SUBJECT: Product Support Plan for 2300D™ and 2301D™ Controls

Attachment A – Wiring Terminal Changes

New Terminal Type:

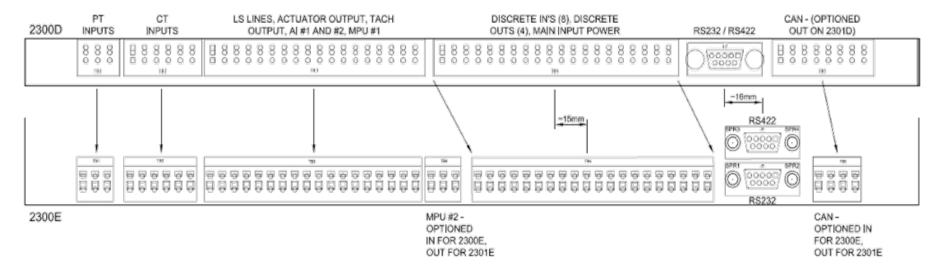
The terminals are changing from the current lever type spring cage connector to a spring cage connector that does not have a lever.

Due to the addition of new I/O in the 2300E model, the terminal spacing on both the 2300E and 2301E will change slightly from the 'D' versions:

- The PT, CT, Actuator Out, Analog In, and 1st MPU input connections are not moved.
- The Discrete In, Discrete Out, and main power input connections are moved to the right approximately 15 mm.
- The RS-232/RS-422 port moves to the right approximately 13 mm.
